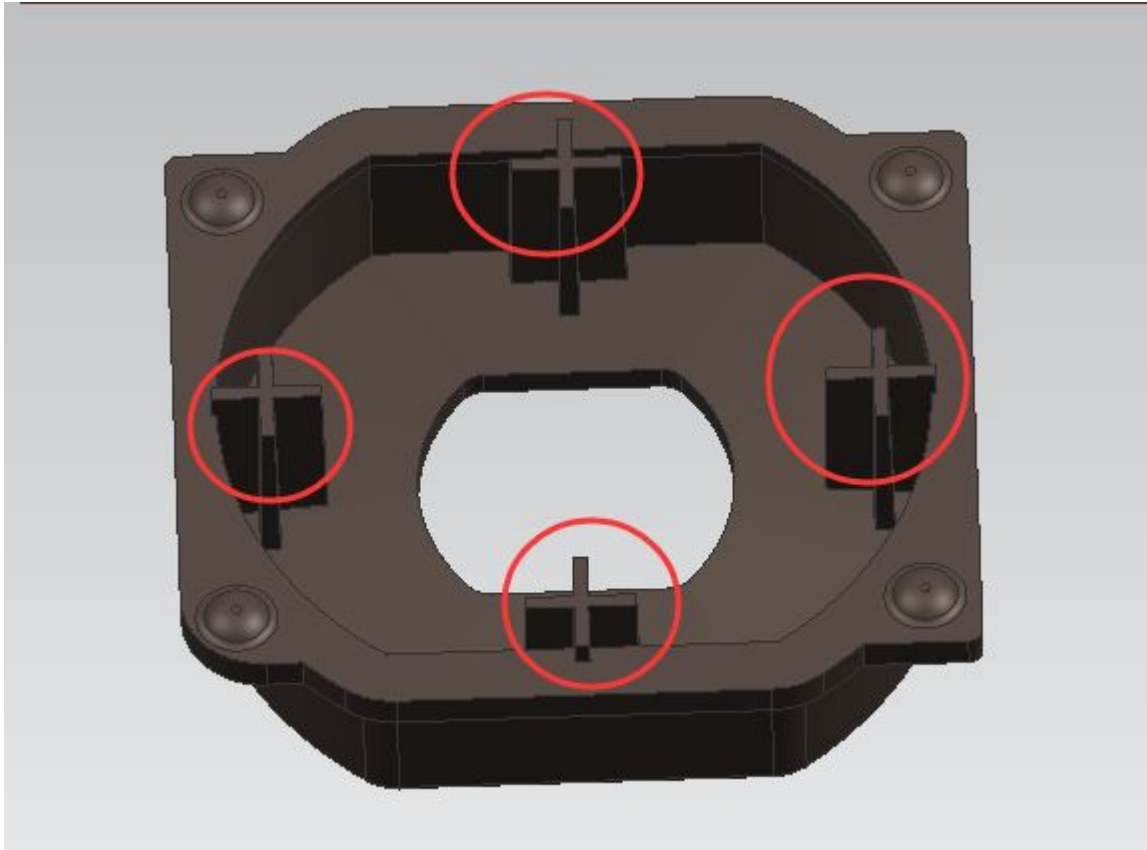
the rubber keypads have been increased 0.4mm as the red arrow direction, and other keys no changes, please check whether the 3D drawings are correct

joystick

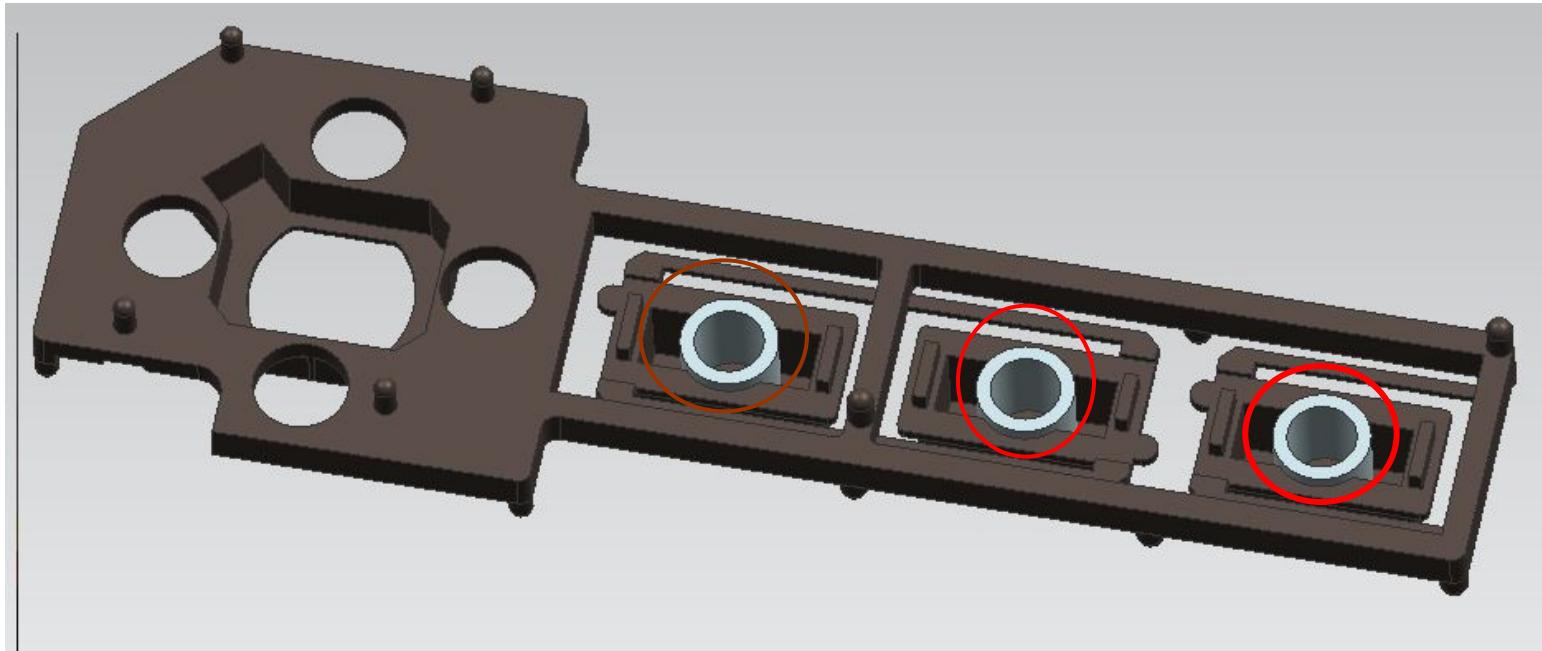
However, we suggest not to increase these keys; the plastic keyboards have to decrease 0.4mm if you want to increase 0.4mm for the rubber keypads, therefore, the plastic keyboard will be in a compression state during assembly.

do the four cross ribs have to change to round ribs?

The cross ribs have been changed to round ribs with ϕ 6.8mm
